**ADDENDUM No. 3**  
**REQUEST FOR TENDER No. 101-2019**  
**CLOSING: 12:00 NOON (LOCAL TIME), April 12, 2019**

**For: The supply of all labour, products, equipment, and supervision required to complete state-of-good repair work at Alexandra Park Outdoor Pool on behalf of the Parks, Forestry and Recreation Division of the City of Toronto**

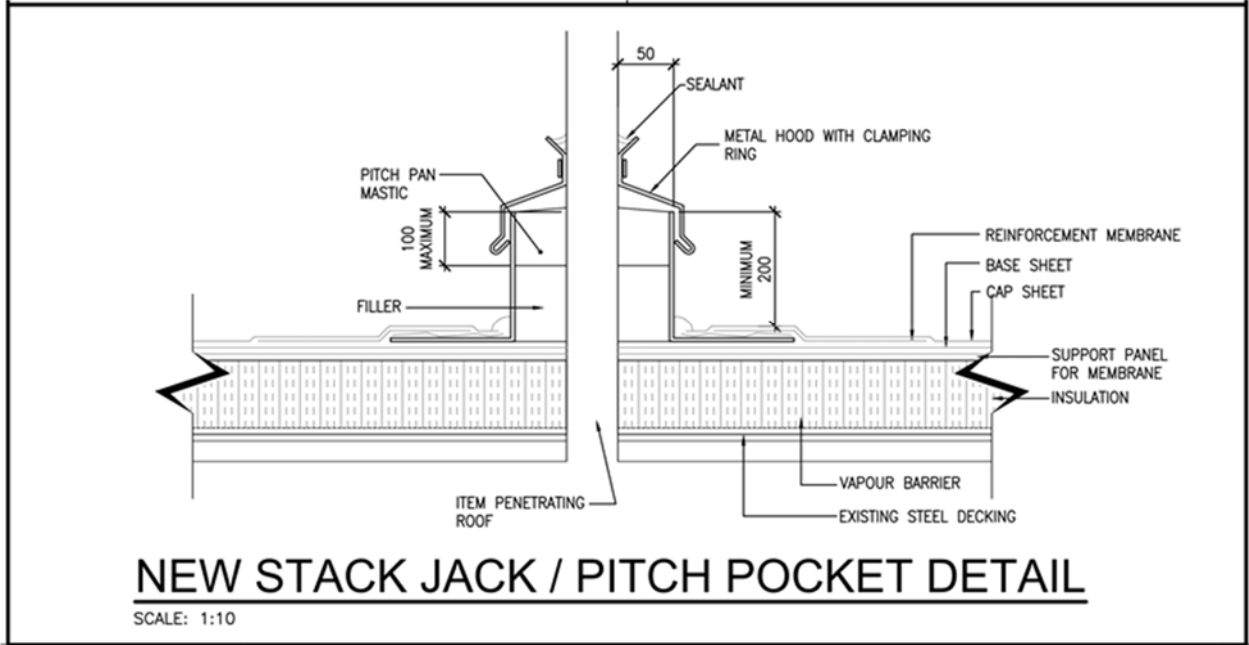
**Q2.** *Please provide also a detail for the S. Steel vanity brackets*

**A2.** Stainless steel vanity brackets shall be similar to Federal Brace Streamline countertop bracket shown below, or an alternate provided by the millwork sub-contractor. Material to be stainless steel, 7 gauge, 500 lbs capacity. Bracket to be capable of providing all barrier free clearances.
